NOV\_SCE\_MYU\_ 20220406-01

## **NOTICE OF VIOLATION**

Report Name: MYU\_SCE\_20220406-01  
Date(s): April 6, 2022  
Inspector: Matthew Yunge  
Utility: Southern California Edison  
Attention: Erik Takayesu, Vice President Asset Strategy and Planning

On April 6, 2022, I performed a walking inspection of Southern California Edison's (SCE) covered conductor installations, 2021 WMP initiative number 7.3.3.3.1, near or in the Tule River Reservation. Detailed findings from this field inspection are laid out in Section II below.

Structure ID: 4477325E

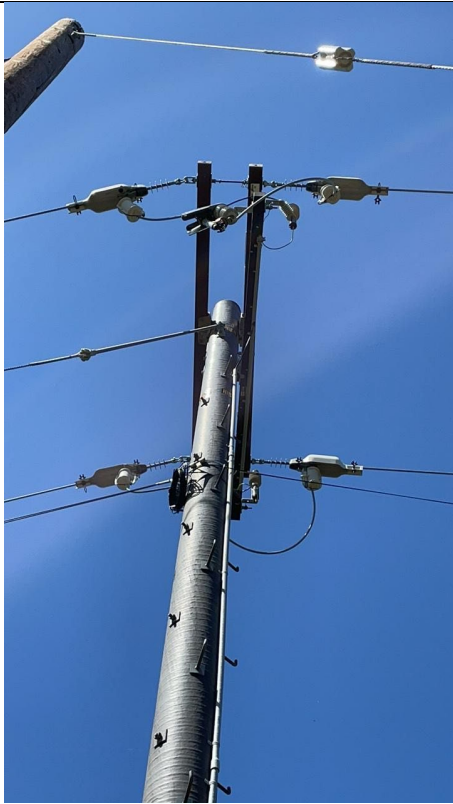
Item2IA1Img1: Missing vibration damper

**Item2IA2Img1:** Missing anti-rotational device at outer notch under dead uncover

Structure ID: 4360581E

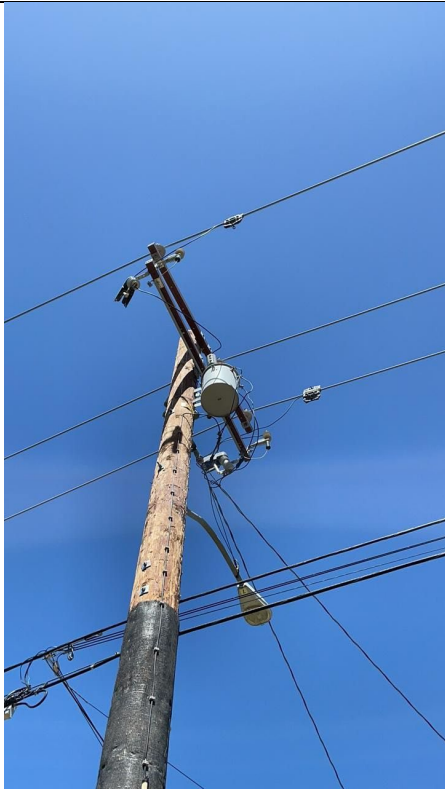
**Item5IA1Img1:** Missing vibration damper
